Access Compliance Report

Public Rights-of-Way

(Curb Ramps)

Intersection ID: 7762	Main Street: N_GRAHAM_ST	Cross Street: W_CRAIGHEAD_RD	Location: SE
ADA ID: 62BE2A226E9B	Ramp Type: Para	Initial Pass/Fail: Fail	Overall Compliance: No
Codes/Mitigation Info/Possible Solution		Field Measurements/Component Compliance	
Severity Score: 13.75

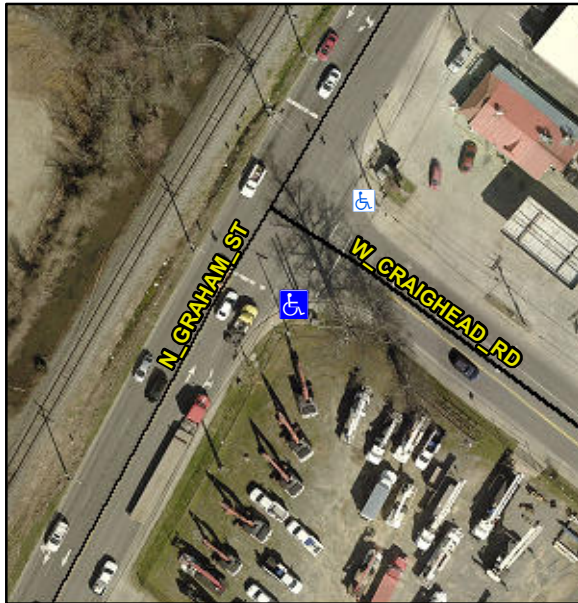
DAMAGED CURB, LT RP < 5%

R304.5.3, R304.3.2

Compliance	Description	Data	Compliance	Description	Data
N/A	Ramp Length LT (in)	62.0	N/A	Ramp Length RT (in)	66.5
Yes	Ramp Width LT (in)	59.5	Yes	Ramp Width RT (in)	59.5
Yes	Ramp Slope LT (%)	4.6	No	Ramp Slope RT (%)	8.7
No	Ramp XSlope LT (%)	2.6	Yes	Ramp XSlope RT (%)	0.9
N/A	Landing Length (in)	N/A	N/A	DWS Provided?	N/A
N/A	Landing Width (in)	N/A	N/A	DWS Contrast?	N/A
N/A	Landing Slope (%)	N/A	N/A	DWS Length (in)	N/A
N/A	Landing X Slope (%)	N/A	N/A	DWS Full Width?	N/A
N/A	Landing Curb? (Y/N)	N/A	N/A	DWS Offset (in)	N/A
N/A	Shared Landing?	N/A			
N/A	Gutter Ponding?	N/A	N/A	Gutter Slope (%)	N/A
N/A	Gutter Lip Ht (in)	N/A	N/A	Gutter X Slope (%)	N/A
N/A	Painted X Walk1?	Yes	N/A	Painted X Walk2?	N/A
	X Walk 1 Direction	To NE		X Walk 2 Direction	N/A
N/A	X Walk 1 Width (in)	103.5	N/A	X Walk 2 Width (in)	N/A
	X Walk 1 Slope (%)	0.5		X Walk 2 Slope (%)	N/A
	X Walk 1 X Slope (%)	4.6		X Walk 2 X Slope (%)	N/A
N/A	Ramp inside XWalk1?	Yes	N/A	Ramp inside XWalk2?	N/A

Remove & Replace Entire Ramp.
